**TO:** DRB Chairwoman Wolfley & DRB Members

**FROM:** District 4 Coalition's Zoning & Development Committee Jim Griffee, Peggy Neff & Dan Regan, Chair

**DATE:** 3/29/21

**SUBJECT:** Project 2019-002761 – The Peaks by Markana

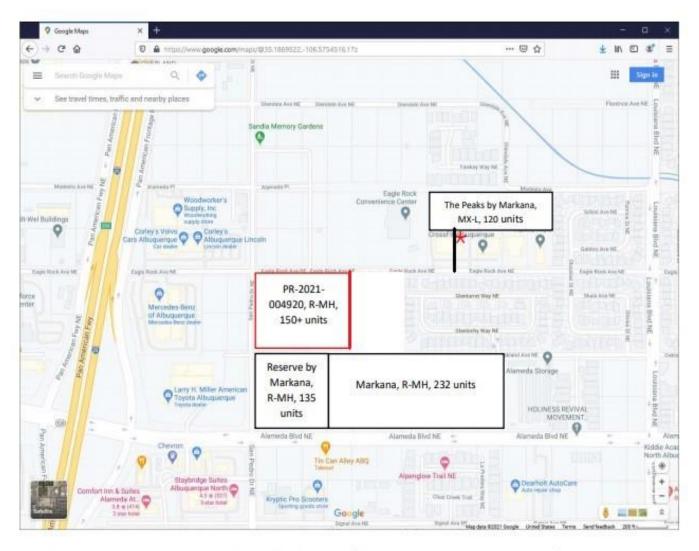
PARKING: The current Site Plan for The Peaks has 120 apratments with 174 beds (in the breakout of single & double bedroom apts.). The developer/agent is required to have 180 parking slots; they are requesting the ability to only provide 174 parking slots (one per bed, conveniently) with NO ACCOMMODATION for ANY visitor parking! If one looks carefully at the immediate surroundings of The Peaks, it is pretty clear that off-site parking of either occupants or visitors will automatically create problems for other residents, both home owners and businesses. The developer would not commit to language in the leases for the Peaks that restrict vehicles to one auto per bed and simply stated that there should be room for Visitors to park. This is not only unrealistic; it borders on the ludicrous! The suggestion that the furtherest east apartment building be eliminated or halved and parking be installed there was met with "that won't work" by the developer.
